IEEE 1904 ANWG

Revision and Maintenance

Opening Report

August 19, 2015
Teleconference

❑ 20150804-1950

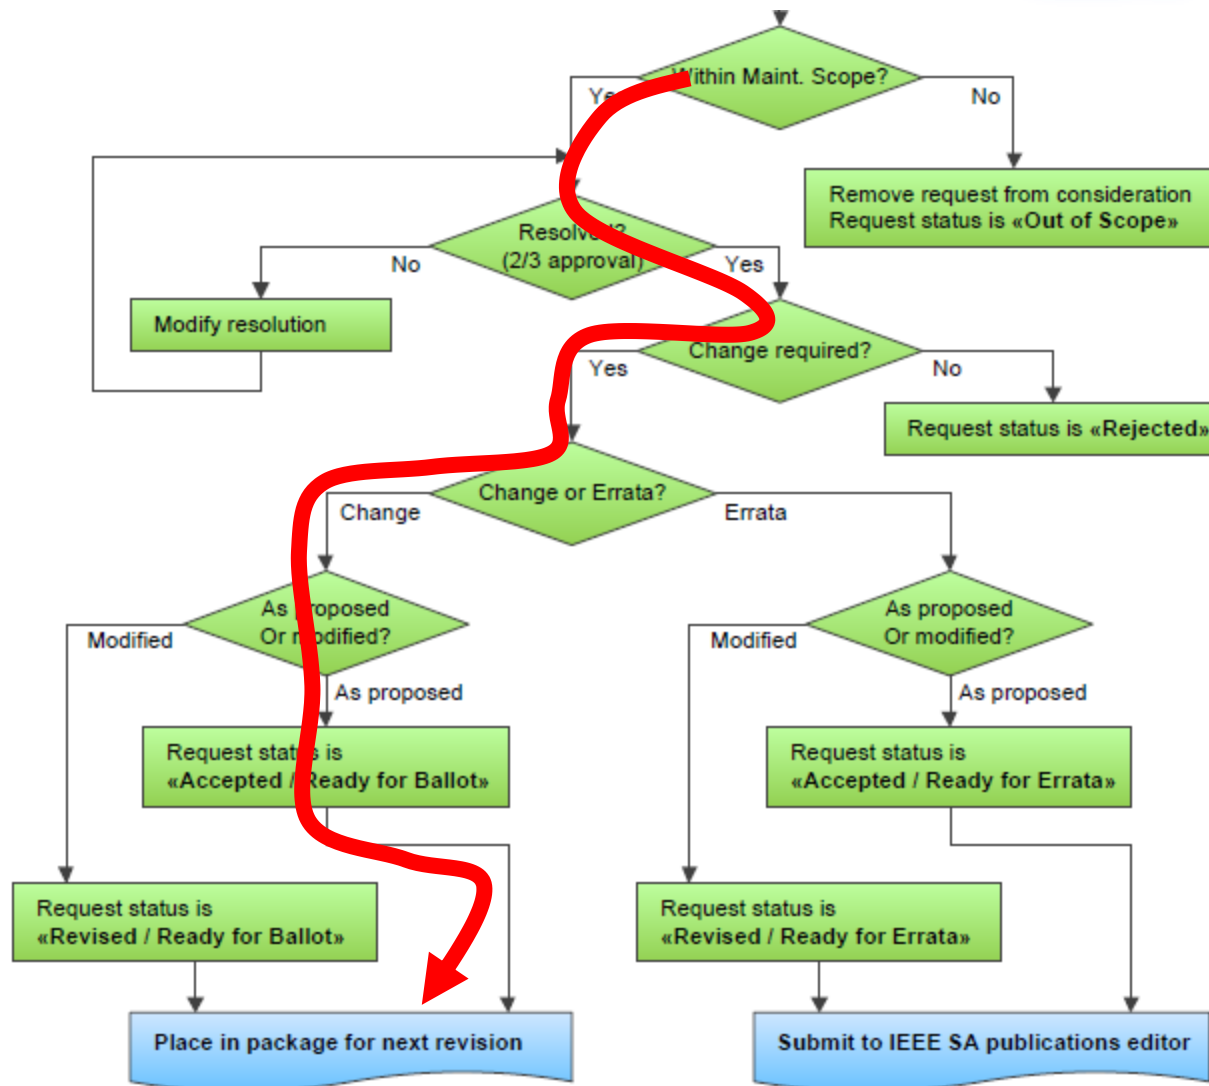
- Use B_DEI instead of B_CFI
